DOD-C-63980 (AR)
AMENDMENT 11
19 April 2000
SUPERSEDING
AMENDMENT 10
16 April 1998

CARTRIDGE, 30MM TARGET PRACTICE, M788

This amendment forms a part of DOD-C-63980 (AR), dated 14 May 1982, and is approved for use by the US Army Armament, Research, Development and Engineering Center, and is available for use by all Departments and Agencies of the Department of Defense.

FIGURE 1: Vertical vibration test schedule

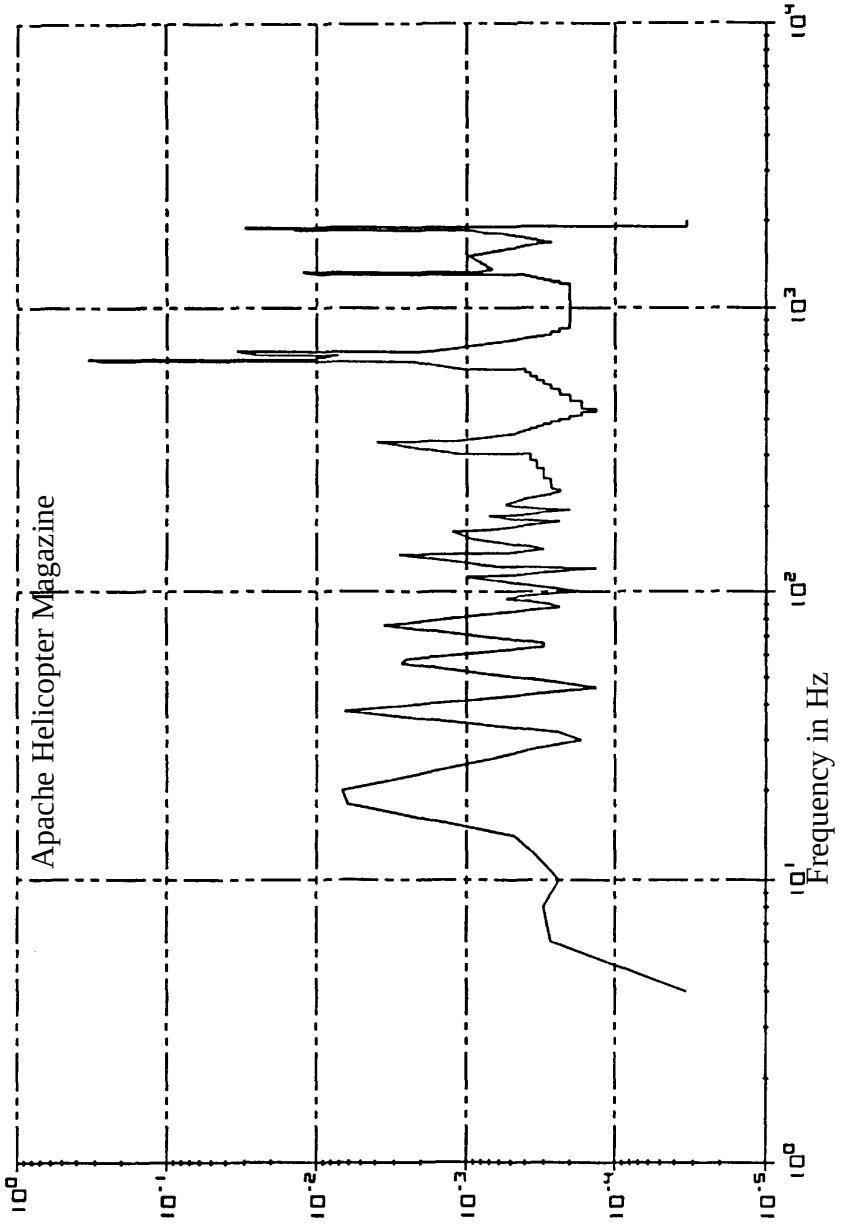
"4.5.9.3. Aircraft vibration: The ammunition loaded in an Apache magazine shall be vibrated according to Figures 1, 2 & 3 and Tables VII, VIII & IX. The magazine shall be mounted to a test fixture in three orientations: vertical, transverse, and longitudinal. The test duration shall be 127 minutes in each orientation and at each temperature of -40^0C and 65^0C. After vibration, the ammunition shall be subjected to the tests in 4.5.9"

Add Figure 1, Vertical vibration test schedule.

FIGURE 2: Transverse vibration test schedule

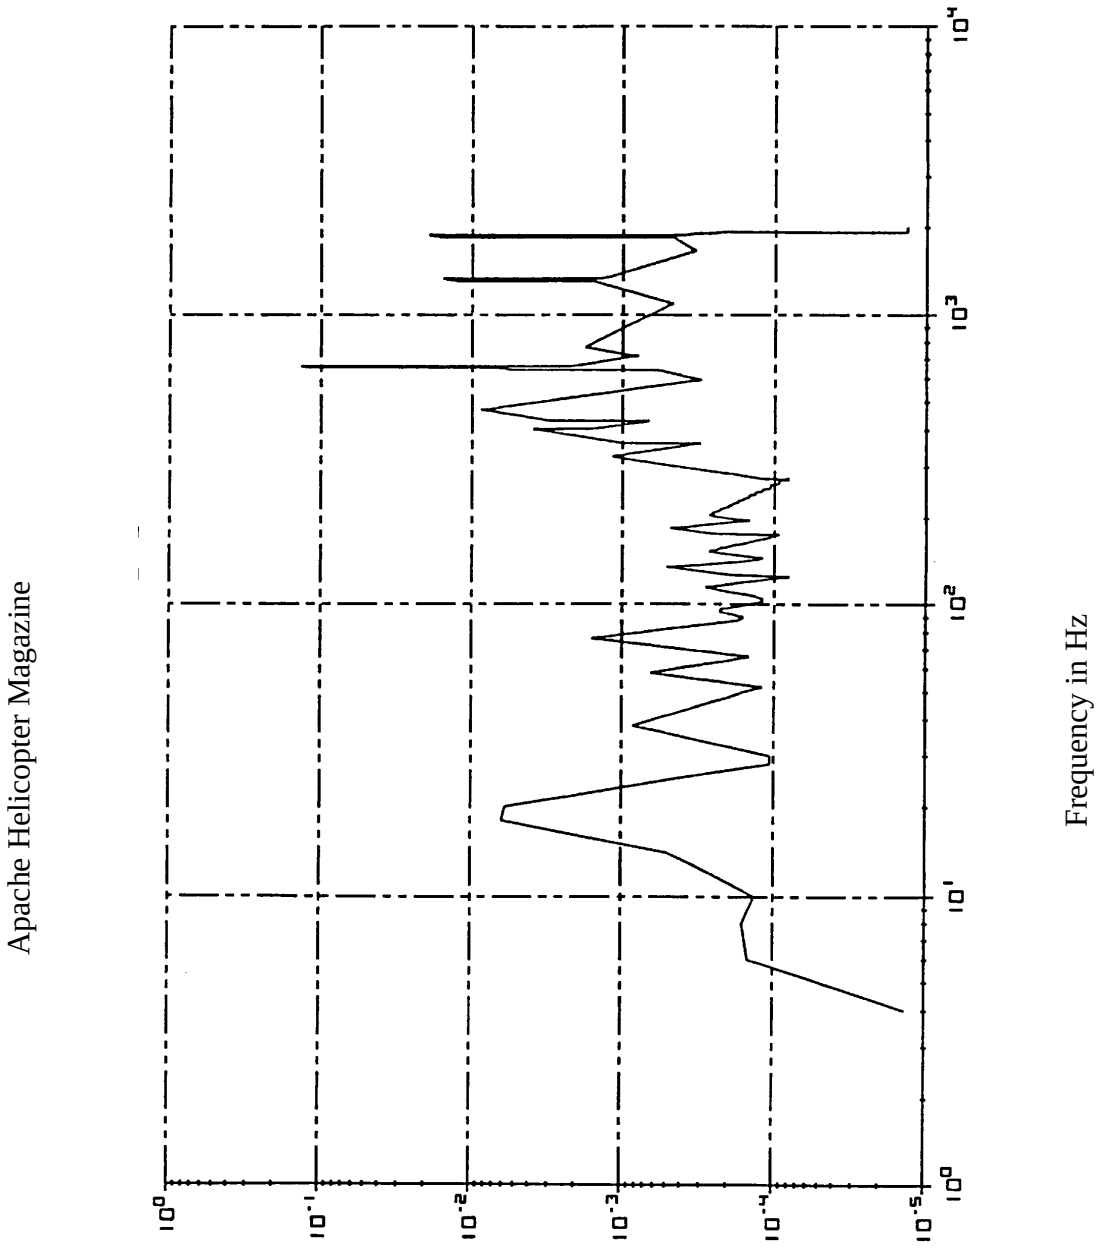
Add Figure 2, Transverse vibration test schedule.

FIGURE 3 : Longitudinal vibration test schedule

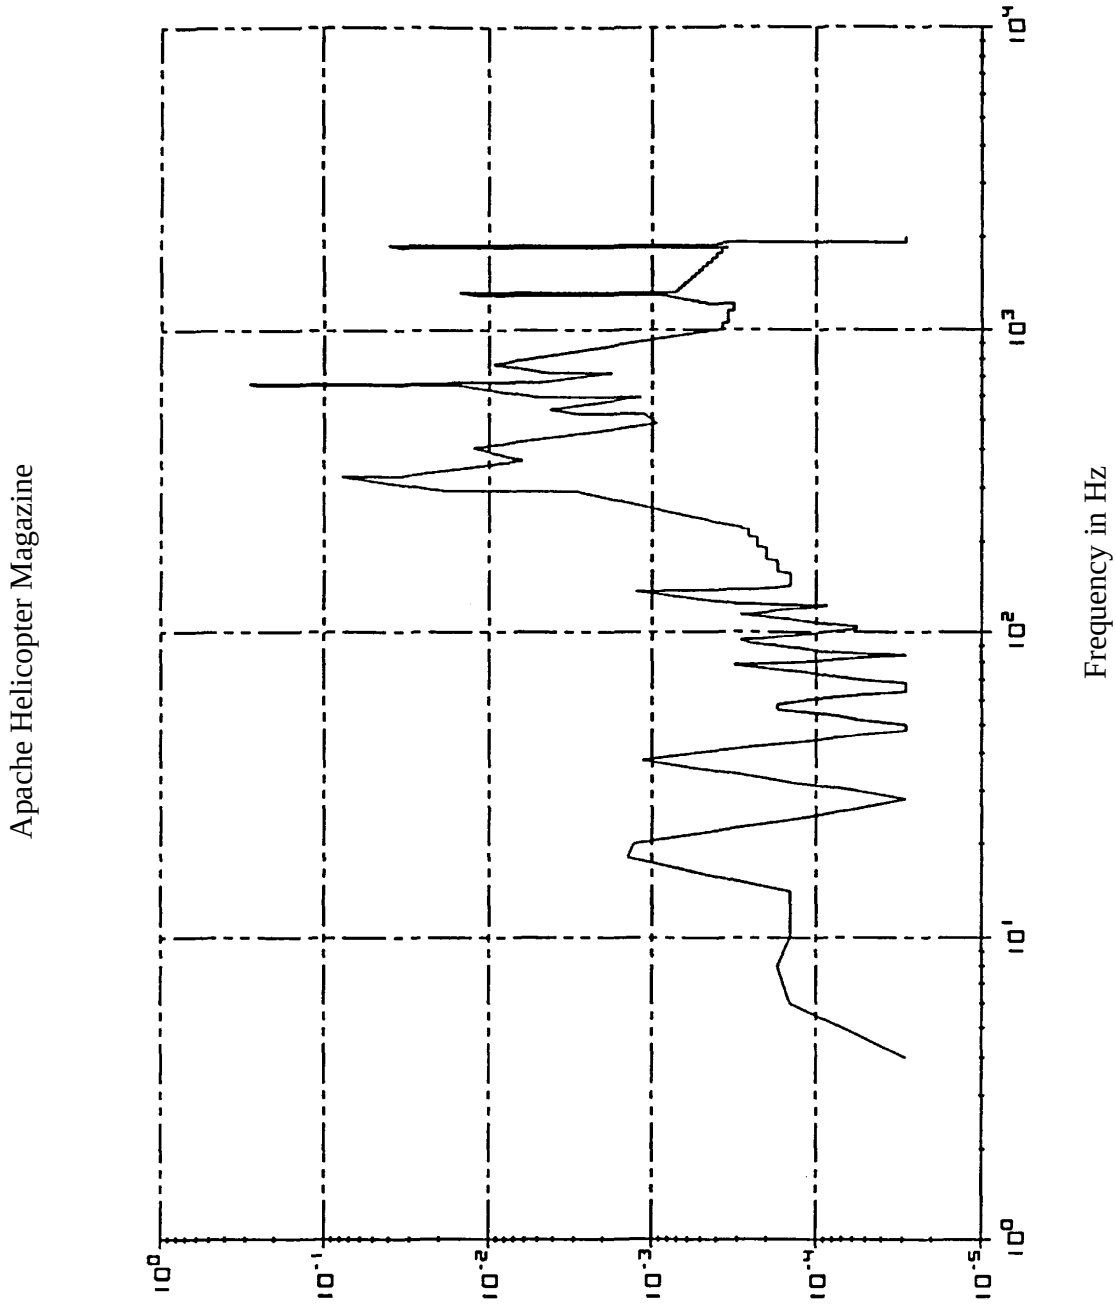
Add Figure 3, Longitudinal vibration test schedule.
